Weston Lea Ltd

HD712 – Amberfield – peer review of the liquefaction assessment

Weston Lea Ltd have engaged HD Geo to undertake a geotechnical peer review of the liquefaction assessment that ENGEO prepared as part of their Geotechnical Investigation Report for the subdivision. In this letter, we have presented the findings of the review and provided recommendations.

PLAN OF LIQUEFACTION POTENTIAL

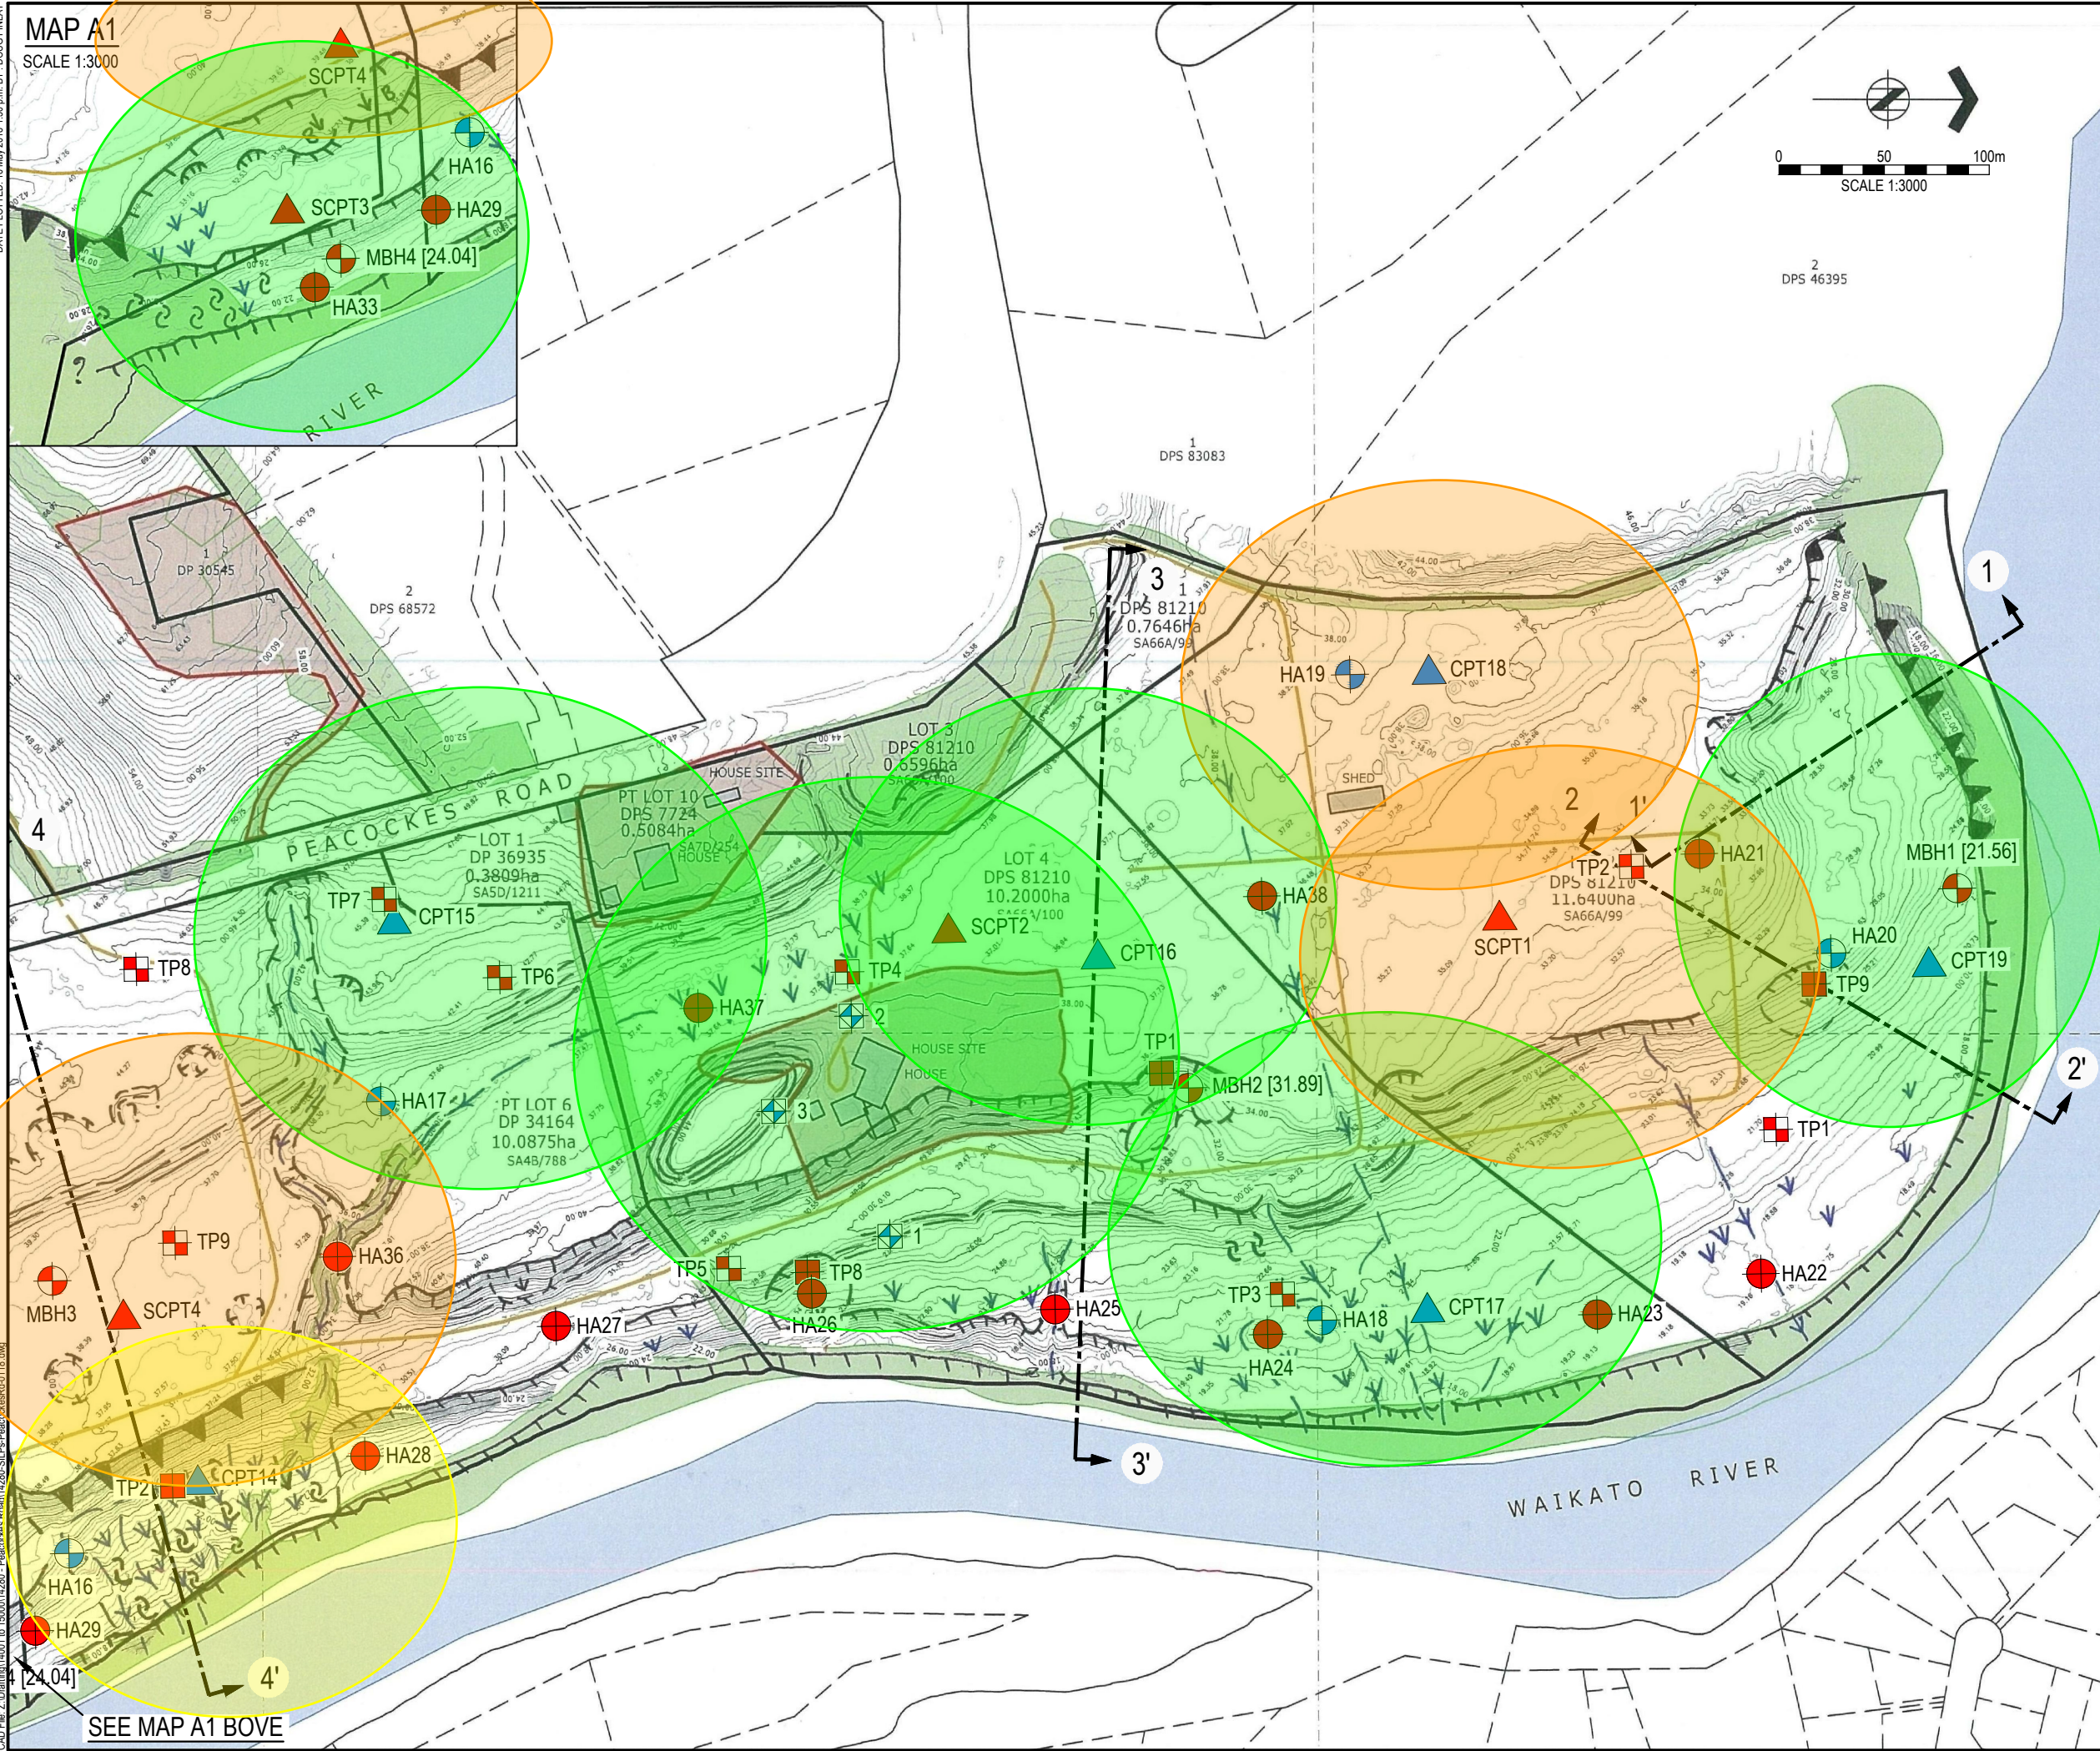
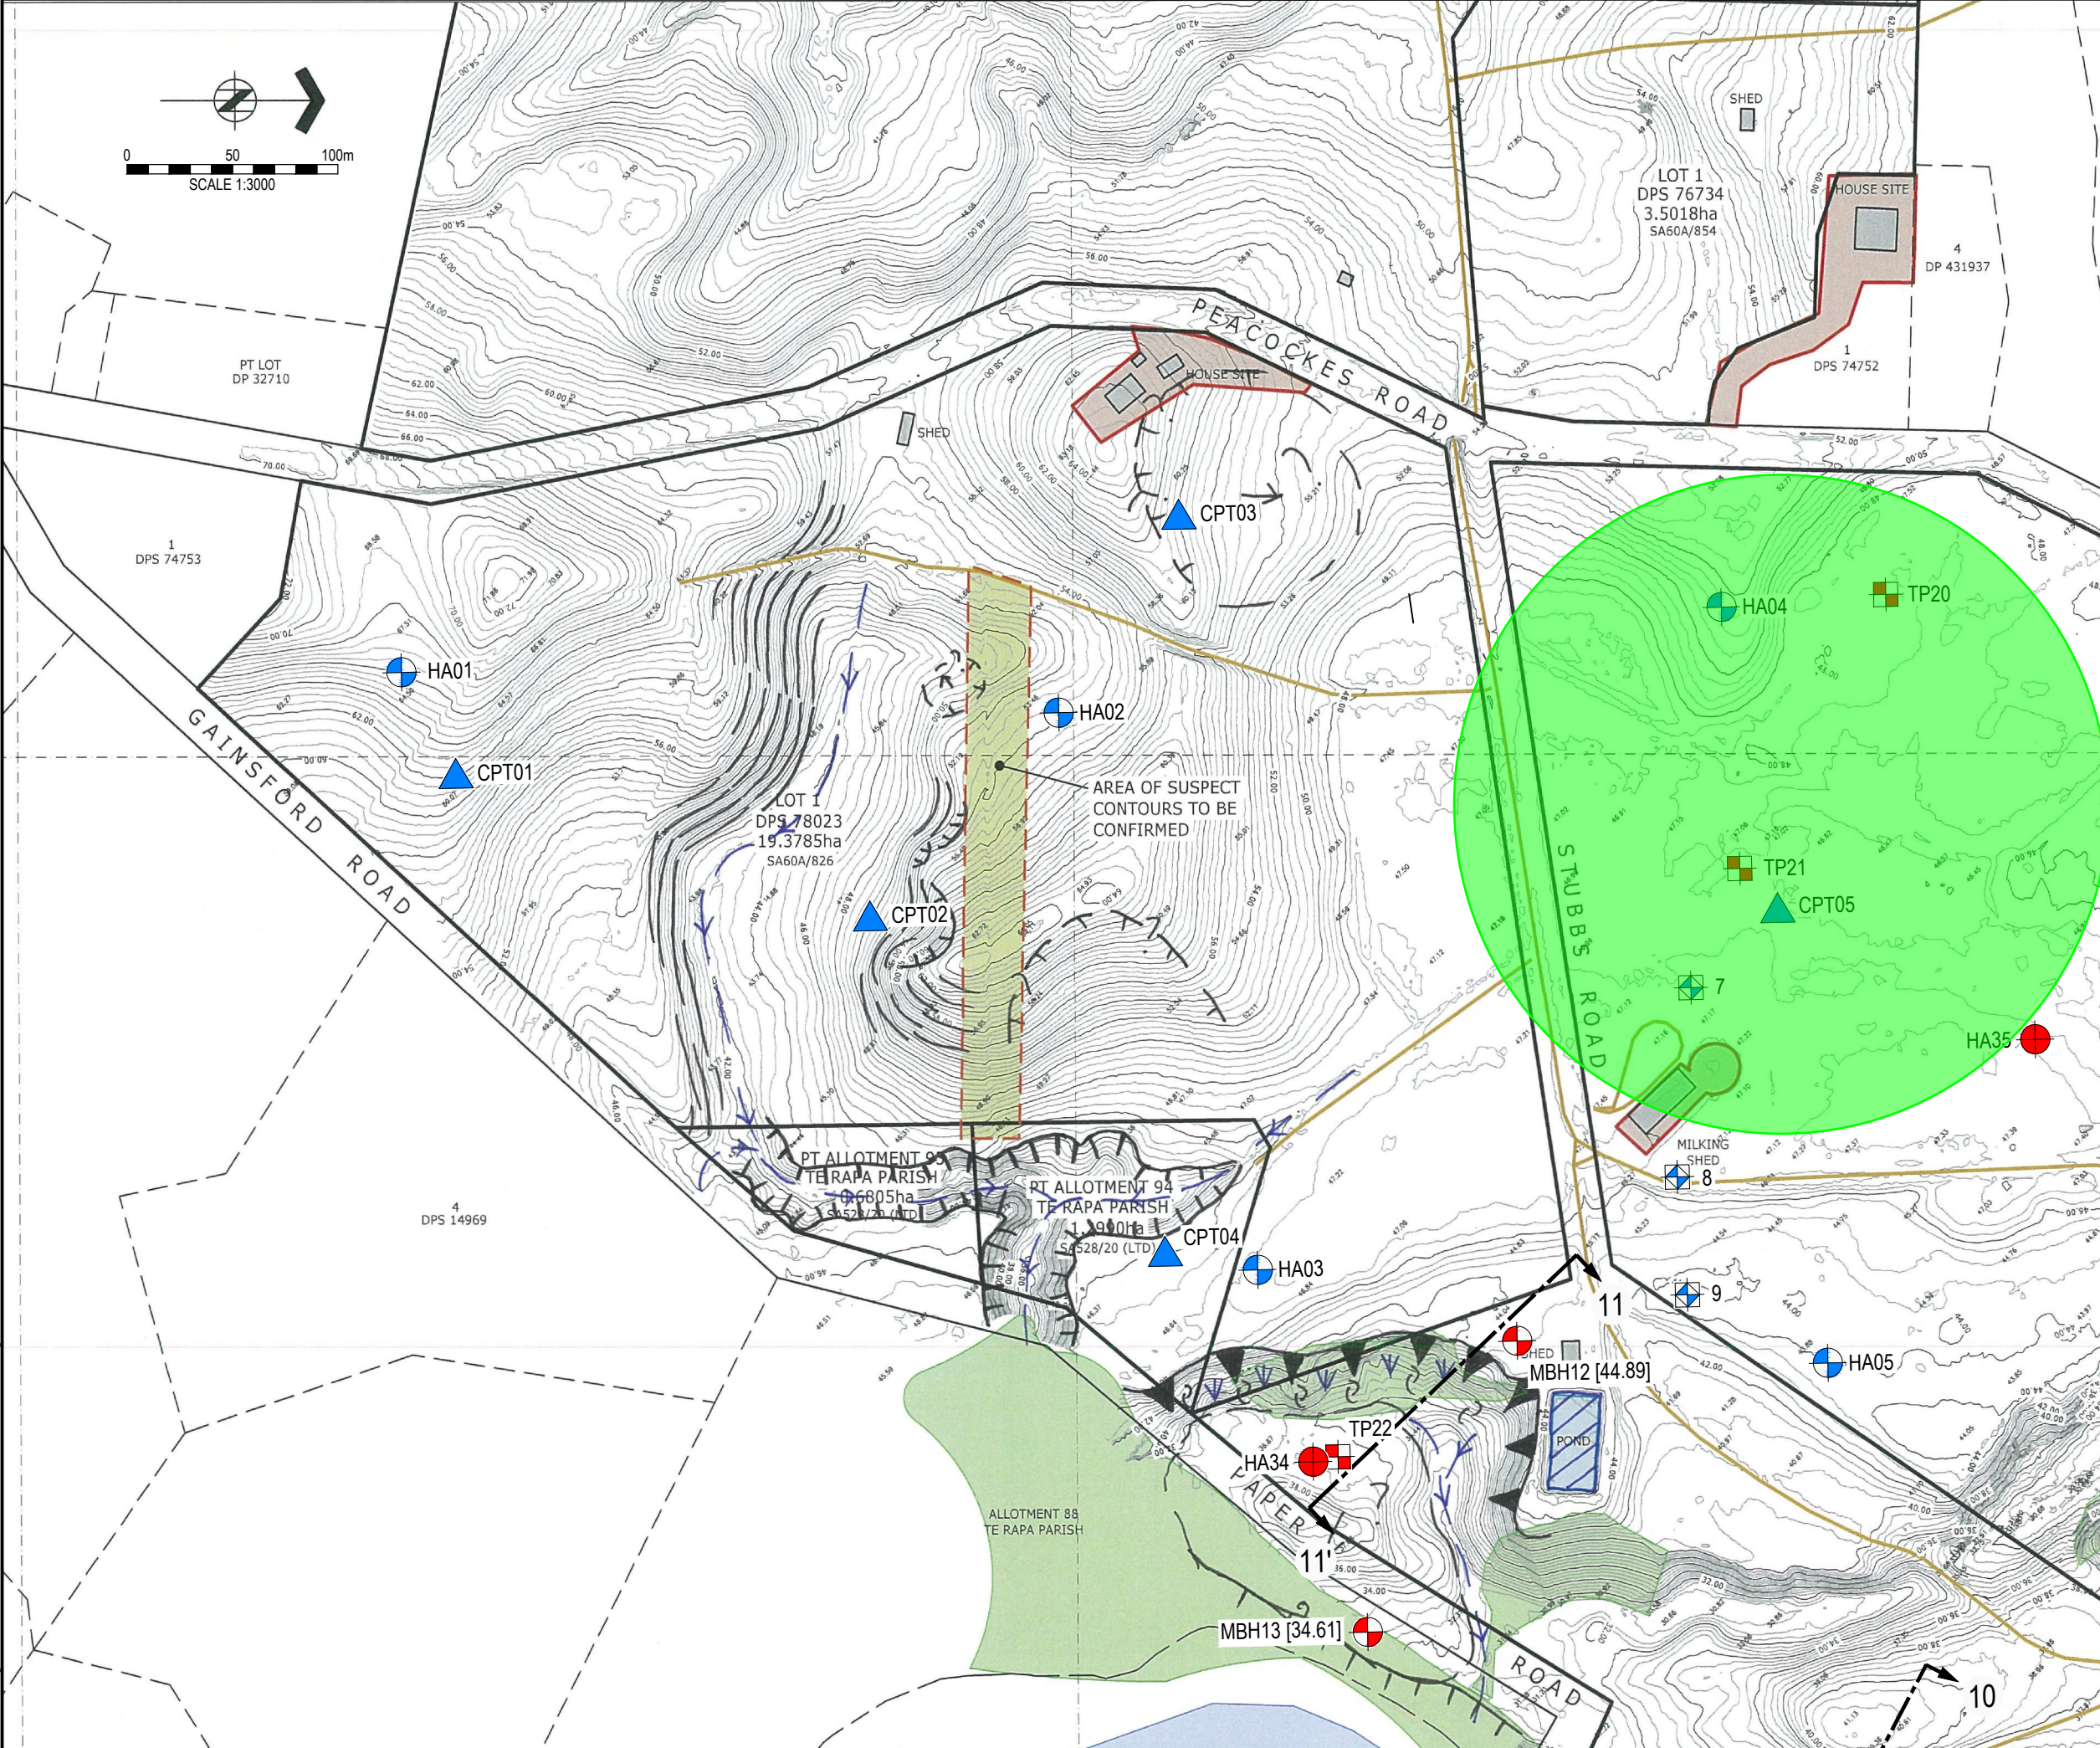
HD Geo 5	The current 'geotechnical constraints' plans are limited to the impact of slope stability. Consider re-naming the plans to reflect the hazard that they cover and present another plan that shows the liquefaction hazard.	Liquefaction hazard now shown on plans	Liquefaction hazard plans reviewed. Approach shows areas where additional assessment should be focused to define areas needing mitigation/special considerations for development.
HD Geo 6	Slope stability modelling looks at seismic acceleration applied to the ground models but does not consider a post earthquake, liquefied case. Has consideration been given to assessing lateral spreading this way?	The risk of liquefaction is considered low as per the revised analyses. Updated stability modelling shows anticipated instability related to liquefied layers matches closely with currently presented constraints plan.	Analyses have been reviewed. The existing constraints plan appears to cover the potential extent of liquefaction related instability. No further work required for suitability stage – recommendations for refining areas and mitigation needed as above.
